Austin Parks and Recreation Department

# Appeal of the Parkland Dedication Land Requirements for Koenig Multifamily (SP-2020-0419C)

Parks and Recreation Board

September 14, 2021

FIGURE A - CURRENT PROPOSED SITE PLAN / PARK PLAN

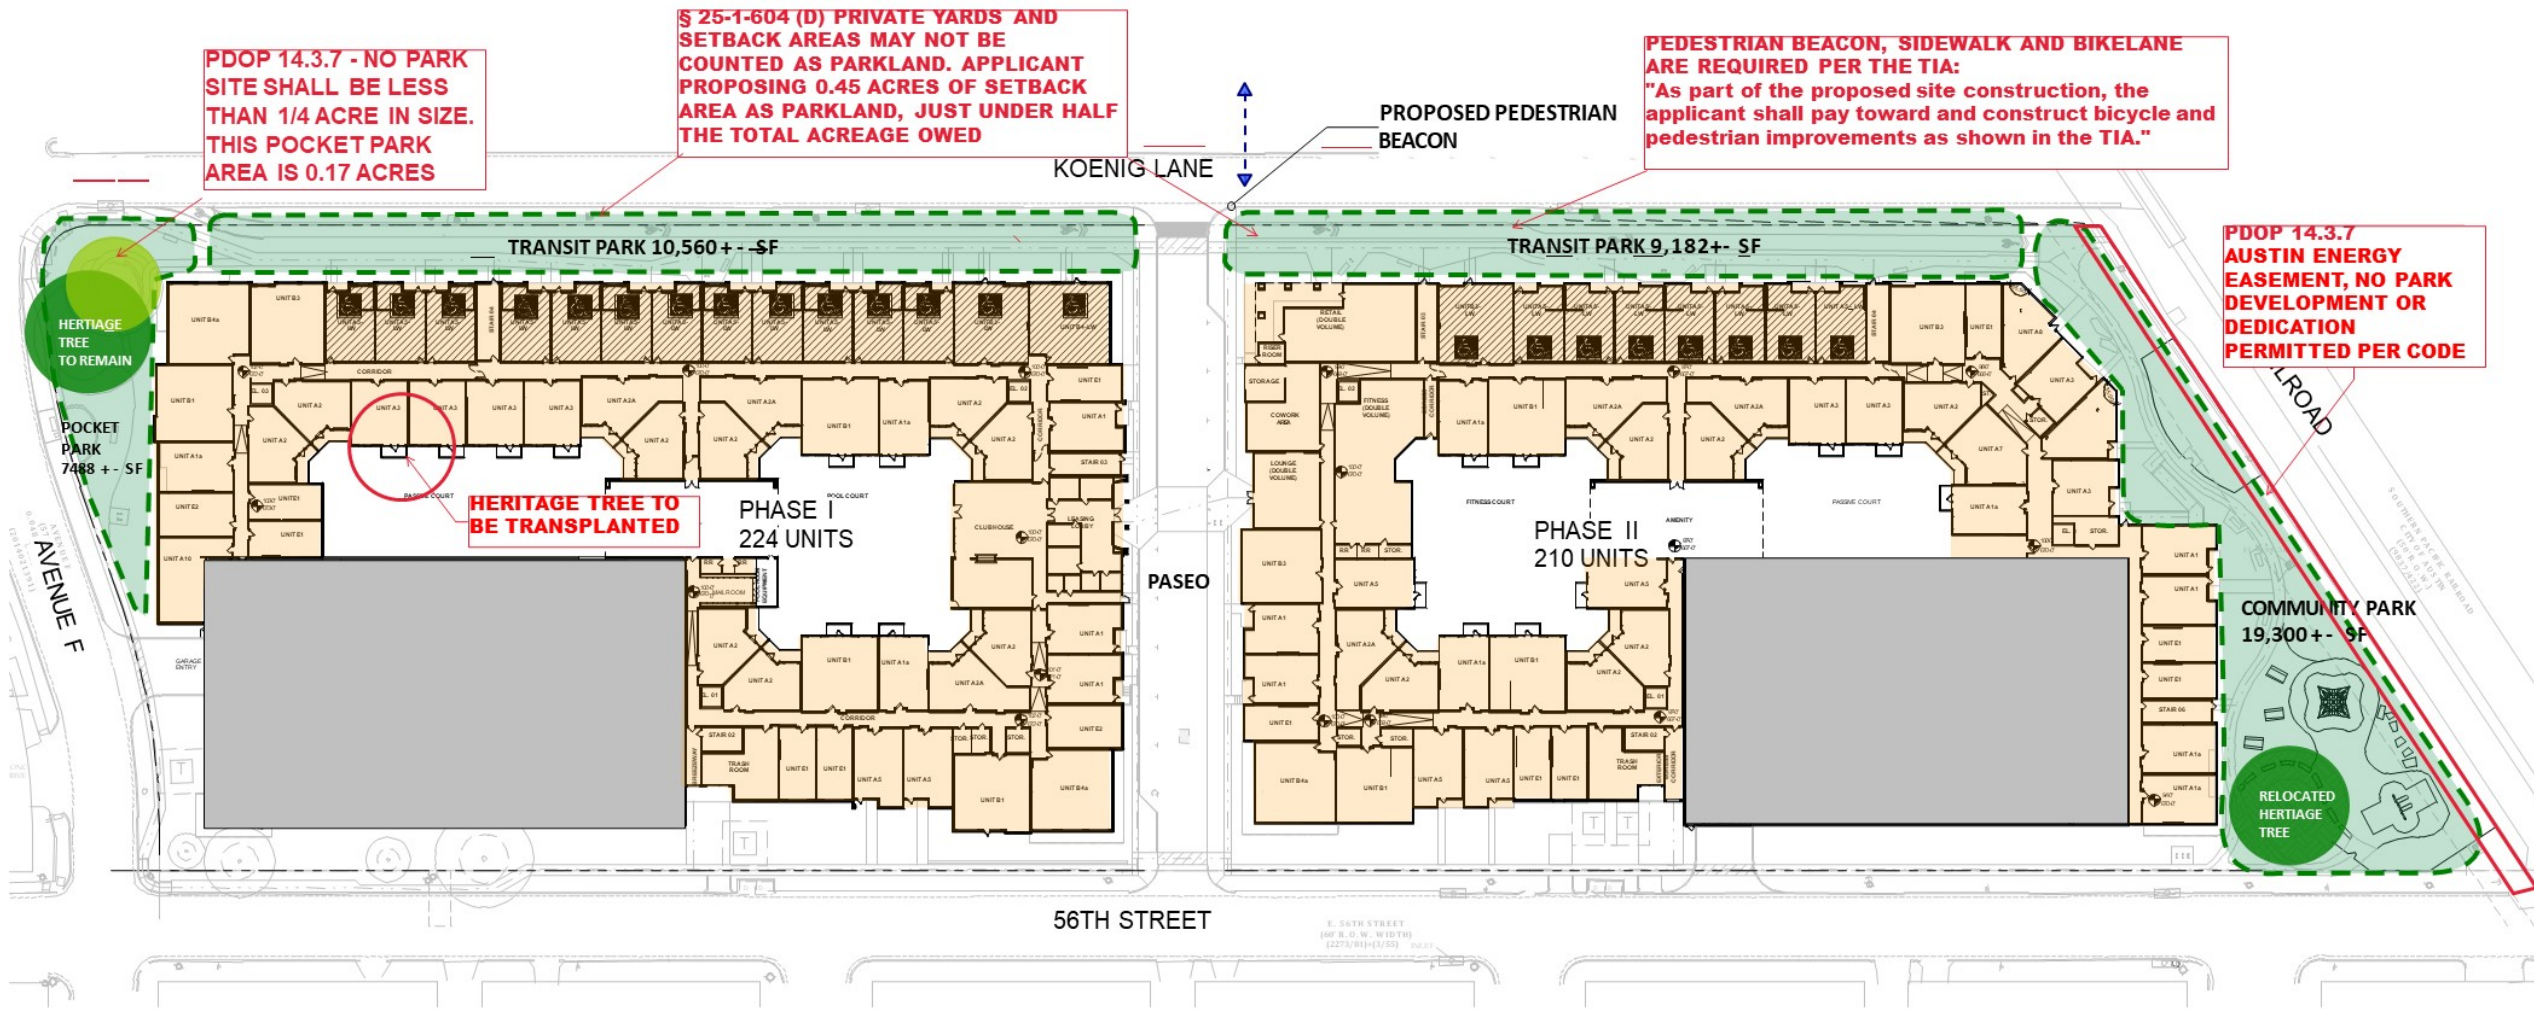
**Based on these criteria, PARD must require land, and does not have the authority to accept fee in lieu.**

(D)**Yards, setback areas**, and private personal open spaces required by this title **may not be counted as private parkland under this section**, except for a required setback or yard that includes a public trail.

(3) The proposed land **shall not be encumbered by recorded easements**, or easements proposed to be recorded, such that it prevents construction of recreation amenities desired on the parkland.

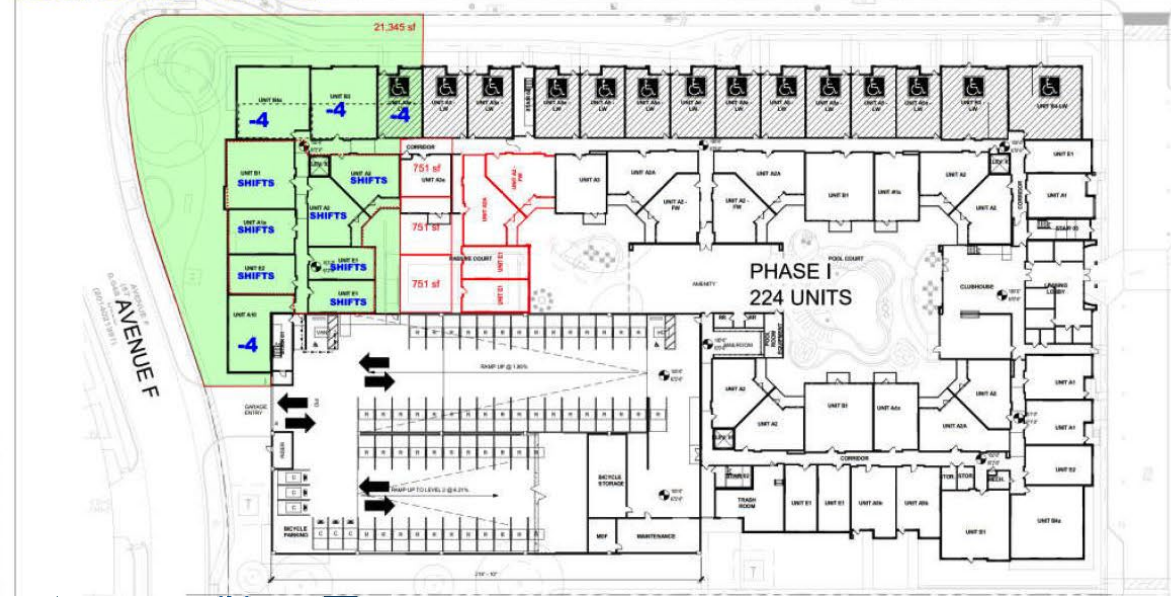
- Applicant is satisfying parkland dedication with a combination of land dedication and fees in-lieu as authorized under City Code § 25-1-605(E). **The majority (86%) of their parkland requirement will be met with fees in-lieu due to the 15% Urban Core cap.**

- No available land to purchase for parkland within a quarter mile of the site - 100% fees-in-lieu not useful for land acquisition in this neighborhood.

- Paseo required as an internal circulation route - not required to have vehicular use, only pedestrian and bicycle.
- **The Director is not authorized to accept in-kind land donations in lieu of land dedication requirements. In-kind land donations are not code criteria listed in current code 25-1-605 B for considering whether land or fee may satisfy parkland dedication.**

## PARD OPTION 3

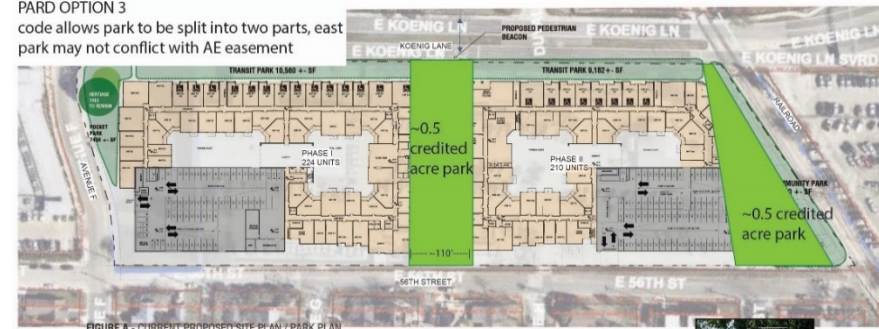
code allows park to be split into two parts, east park may not conflict with AE easement

## PARD OPTION 2

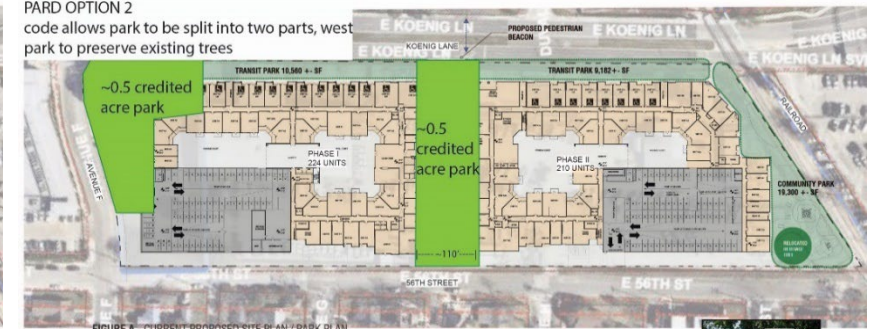
code allows park to be split into two parts, west park to preserve existing trees

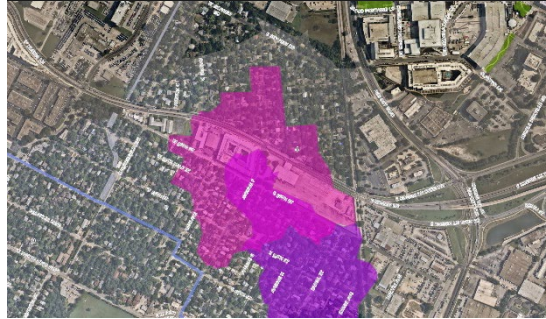
**Parkland should provide *increased* connectivity. The bike lane and sidewalk required by the TIA does not provide sufficient *increased* connectivity. There are no opportunities for group gathering, outdoor play or health-enhancing activities that the required sidewalk doesn't already provide**

# PARD vs Applicant Alignment

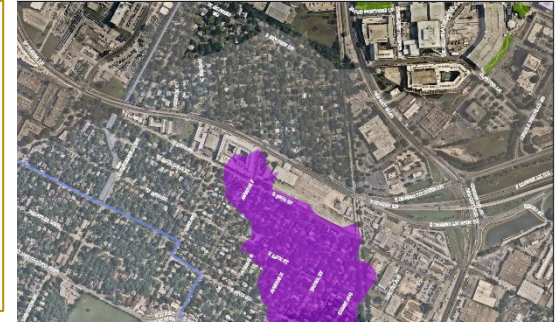
PARD approved alignment provides parkland on the North West corner of the site and a much larger park service area.

Applicant proposal includes only one park on the South East corner of the site and no parkland at Koenig and Ave F.
